Plan View

Locator Map

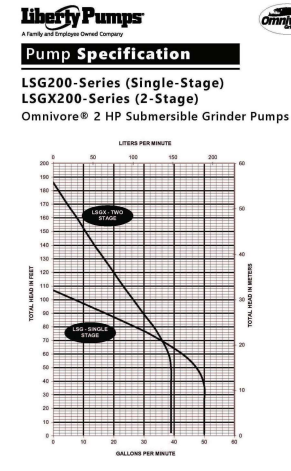
1. EXISTING SANITARY SEWER SERVICE SHALL NOT BE INTERRUPTED.
2. CONNECTION TO DUCKETT CREEK SEWER DISTRICT (DCSD) SANITARY SEWERS REQUIRES DCSD INSPECTION. CONTACT THE DCSD INSPECTION DEPARTMENT AT (630) 441-1244 TO SCHEDULE INSPECTION. 48 HOUR NOTICE REQUIRED.
3. ALL LATERALS UNDER ANY FUTURE PAVEMENT WILL REQUIRE GRANULAR FILL TO TOP OF TRENCH AND/OR BOTTOM OF PAVEMENT SECTION.
4. FUTURE LOTS INCLUDING THE CAR WASH REQUIRE SEPARATE PLAN REVIEW AND APPROVAL.
5. EACH BUILDING MUST HAVE ITS OWN CONNECTION TO THE PUBLIC WASTEWATER FACILITIES.
6. IT IS THE RESPONSIBILITY OF THE OWNER/DEVELOPER TO OBTAIN ALL PERMITS NECESSARY FOR THE PROJECT.
